TECHNICAL REPORT

This report presents the results of an independent review of the criticality safety program at the Hanford Plutonium Finishing Plant (PFP). This review was requested by the Department of Energy's Richland Office (RL) to help benchmark the criticality safety program before a formal Operational Readiness Review is performed for the initiation of Phase 2 activities at PFP (Phase 2 is explained later, in Section 2.0 of this report). The review encompassed all elements of the criticality safety program impacting PFP, including management, supervisory, and criticality safety staff responsibilities; operating procedures; process evaluations; material controls; and the planned response to criticality accidents. A key portion of the review, the on-site phase in which the Team toured PFP facilities and interviewed PFP personnel, took place between March 30 and April 3, 1998.

Figure 2. Example of cluttered Criticality Safety Posting for storage and Transportation at PFP

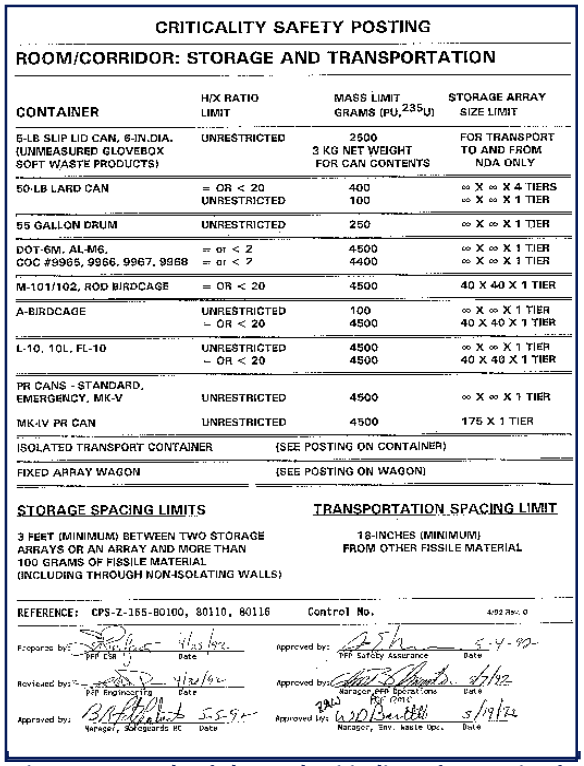
FINDING. *Criticality safety postings do not incorporate good human factors practices.*

The observed postings appeared to contain the necessary and sufficient information on limits and controls that could be manipulated by operators. The postings that were observed provided most of the information in a manner that did not require interpretation. However, some of the information had to be interpreted, e.g., the correct mass limit had to be selectively chosen from several limits, depending on the amount of moderation. It would have been more clear if there had been a one to one correspondence between the mass limit and degree of moderation. The team observed that some postings were cluttered with information and contained information common to criticality safety engineers but not operators. For example, Figure 2 shows the criticality safety posting for room/corridor storage and transportation. The posting contains array definitions that have meaning to the NCS staff but not necessarily to operators. Rather than stating the array is limited to an "infinite by infinite" array, other sites have utilized the term, "one layer planar array".
